STAFF RECOMMENDATION
1404 Gartland Avenue
March 15, 2017

Application: Partial demolition; New construction—addition; Setback determination
District: Lockeland Springs-East End Neighborhood Conservation Zoning Overlay
Council District: 06
Map and Parcel Number: 08309033500
Applicant: Jeff Joachim, Owner
Project Lead: Melissa Baldock, melissa.baldock@nashville.gov

Description of Project: Application is to demolish an existing extension and to construct a new rear addition. The addition requires a side setback determination. On its right/east side, the addition will sit four feet, six inches (4'6") from the side property line, six inches (6") less than the required five foot (5') side setback.

SCALE: 1/4" = 1'
WHEN PLOTTED AT 24 X 36

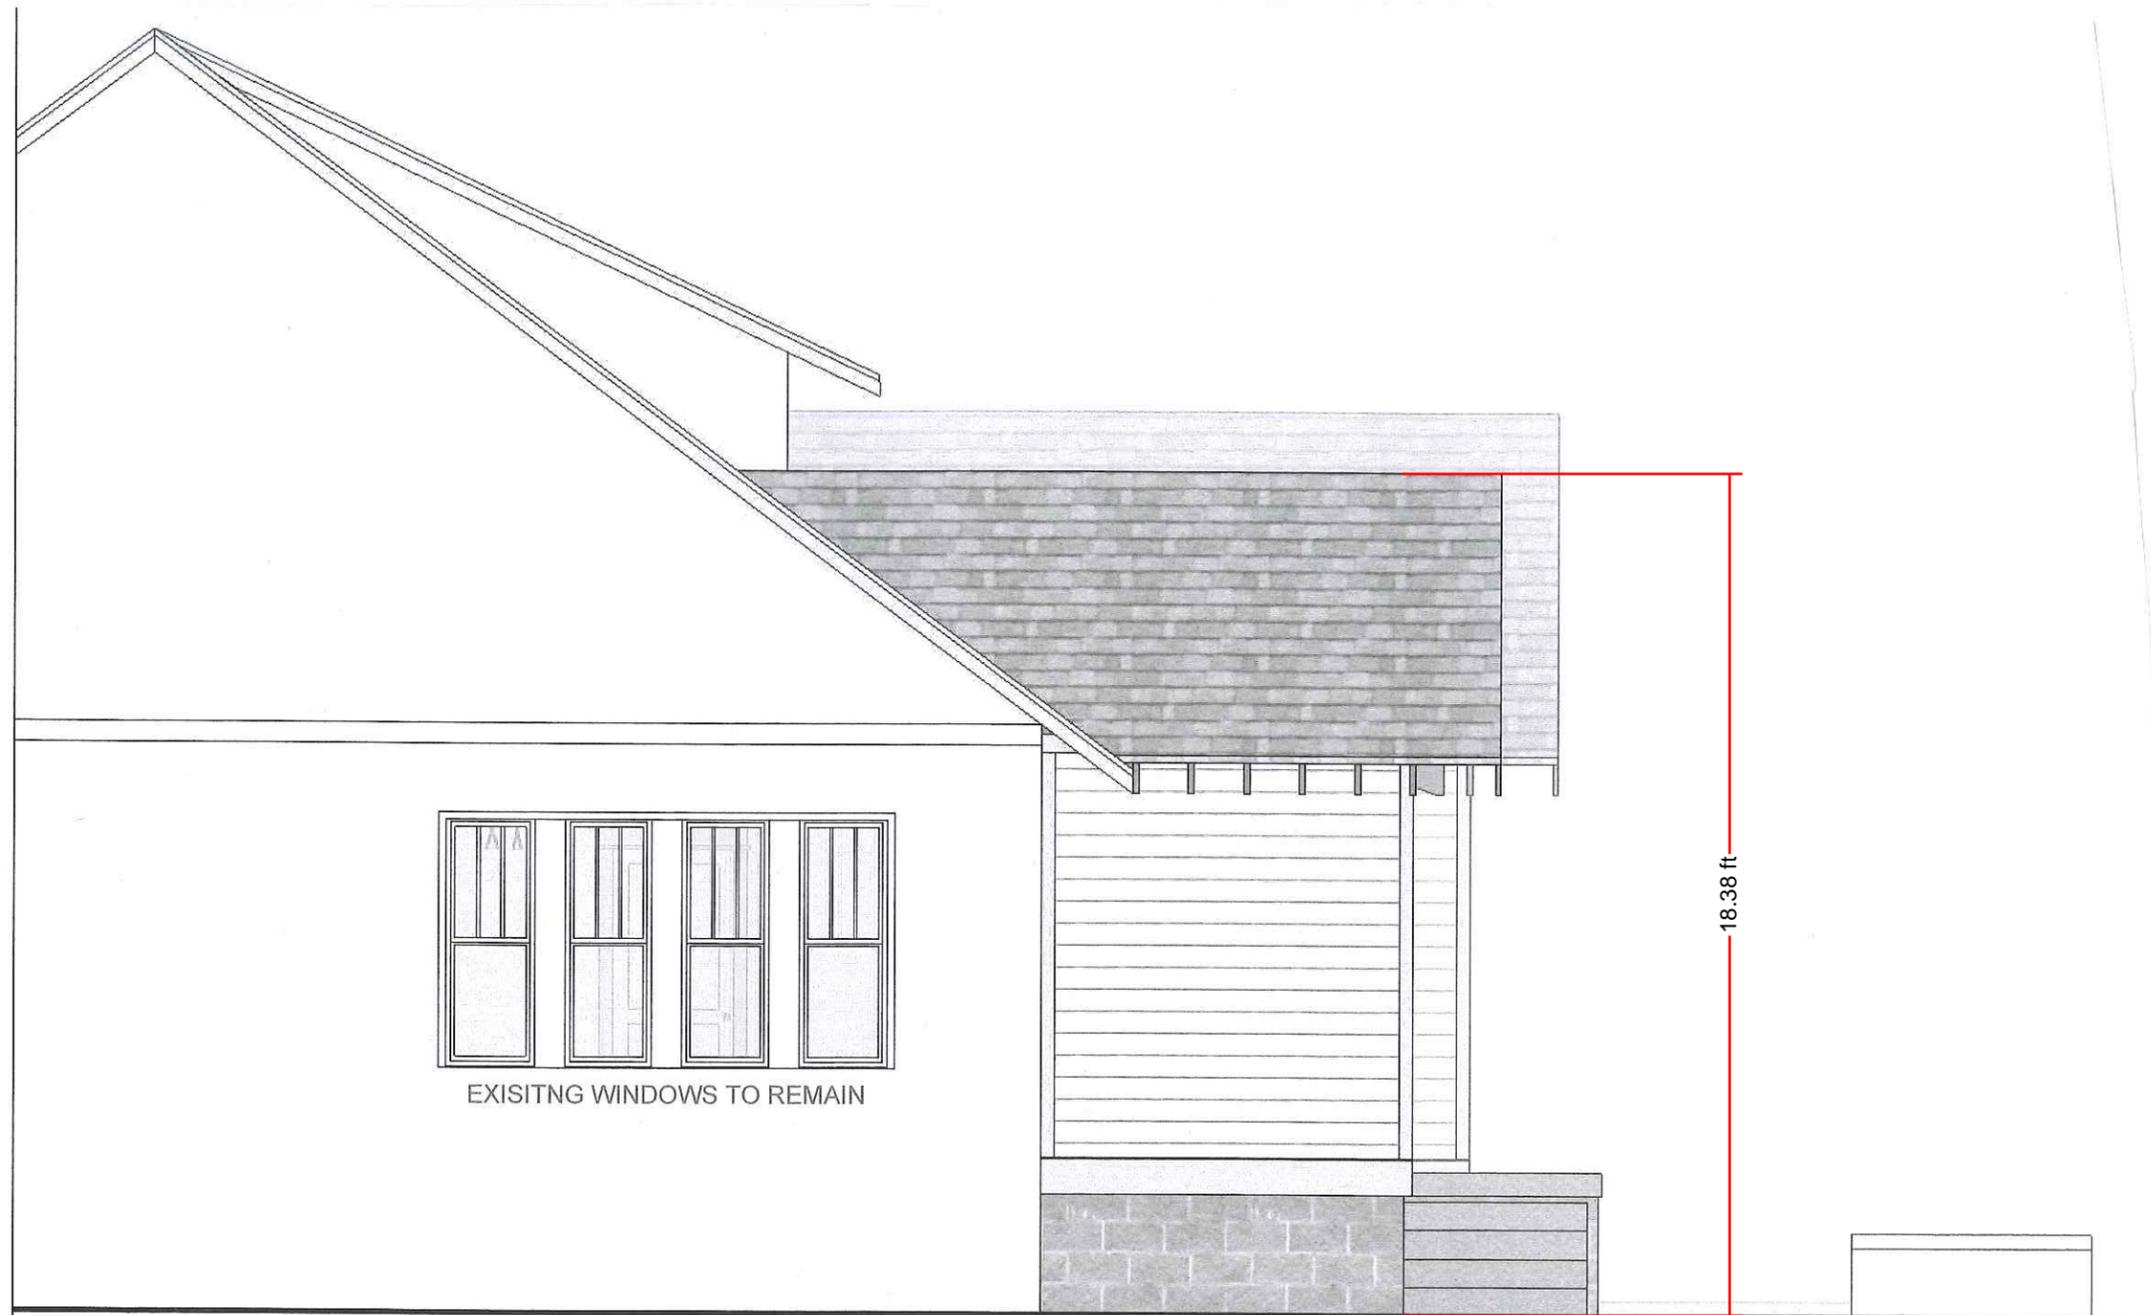
Height & Scale: The proposed addition is one-story in height. Its eave height and foundation heights will match those of the historic house. The addition will have a maximum ridge height of approximately nineteen feet, nine inches (19'9"), which is about eight feet (8') shorter than the ridge height of the historic house.

The addition will add approximately three hundred and eleven square feet (311 sq. ft.) of footprint to the historic house, which has a footprint of over fourteen hundred square feet (1,400 sq. ft.). The addition will inset six inches (6") from the rear walls. Although the Commission typically requires one-story additions like this one to step in one foot (1') from each of the rear corners, staff finds the six inch inset to be appropriate for two reasons. First, the addition is modest in depth and scale. It is only nine feet, three inches (9'3") deep on the left side and eight feet (8') deep on the right side. It is a true one-story addition that is several feet lower than the historic house. Second, there is a change in

Setback & Rhythm of Spacing: The proposed addition requires a side setback determination on the left side. The historic house is shifted on the lot so that it is just four feet (4’) from the right/east side property line. The addition will be set in six inches (6’’) from the back corner of the house, and will therefore be four feet, six inches (4’6’’) from the side property line. This is six inches (6’’) less than the required five foot (5’) side setback. Staff finds that the proposed side setback determination to be appropriate because the addition is no wider than the historic house, and is inset appropriately. Also, the addition has a modest depth of only nine feet (9’), and it is a mere six inches (6’’) less than what is typically required for a side setback. Staff therefore finds that the proposed addition and setback determination meets Sections II.B.3. and II.B.10. of the design guidelines.

Roof form: The addition will have two gabled elements, each with a slope of 9/12, that are connected with a shed roof. Staff finds the proposed roof form to be compatible with the historic house’s side gabled roof form, and finds that it meets Sections II.B.5. and II.B.10. of the design guidelines.

Proportion and Rhythm of Openings: No changes to the window and door openings on the existing house were indicated on the plans. The windows on the proposed addition are all generally twice as tall as they are wide, thereby meeting the historic proportions of openings. There are no large expanses of wall space without a window or door opening. Staff finds the project’s proportion and rhythm of openings meet Section II.B.7. and II.B.10. of the design guidelines.

Appurtenances & Utilities: No changes to the site’s appurtenances were indicated on the drawings. The HVAC units will need to be relocated for the construction of the addition. Staff recommends that the HVAC be located on the rear façade, or on a side façade beyond the midpoint of the house in order to meet Section II.B.9. of the design guidelines.

1. Staff approve the final details, dimensions and materials of windows and doors prior to purchase and installation;
2. Staff approve the roof shingle color; and
3. The HVAC be located behind the house or on either side, beyond the mid-point of the house.
